BUILDING CODE OF AUSTRALIA 2019 (A1)
REPORT

615-617 WARRINGAH ROAD
FORESTVILLE NSW

Educational Establishment

06 January 2022

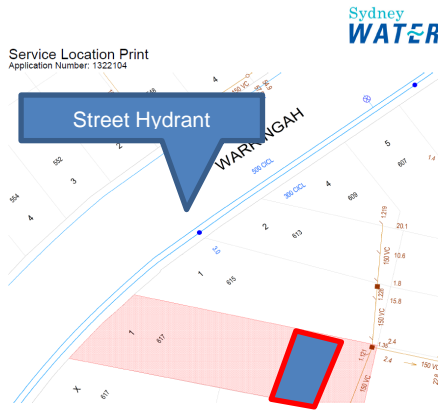
D2.6	Smoke lobbies.	No smoke lobbies utilised.	N/A
D2.7	Installations in exits and paths of travel.	<p>Electrical distribution boards that are located within a path of travel to an exit must be contained within non-combustible construction (metal cabinet) and smoke sealed.</p> <p>Image: Existing electrical distribution board.</p>  <p>Fibro and plasterboard, amongst other materials, are considered non-combustible as per clause C1.9 of BCA 2019 (A1).</p>	Design consideration
D2.8	Enclosure of space under stairs and ramps.	No cupboards proposed beneath the non-fire isolated ramp.	N/A
D2.9	Width of stairways.	No internal stairs more than 2m in width.	N/A
D2.10	Pedestrian ramps.	The external eastern ramp must: (i) where the ramp is also serving as an accessible ramp under Part D3, be in accordance with AS 1428.1; or (ii) in any other case, have a gradient not steeper than 1:8.	Design consideration
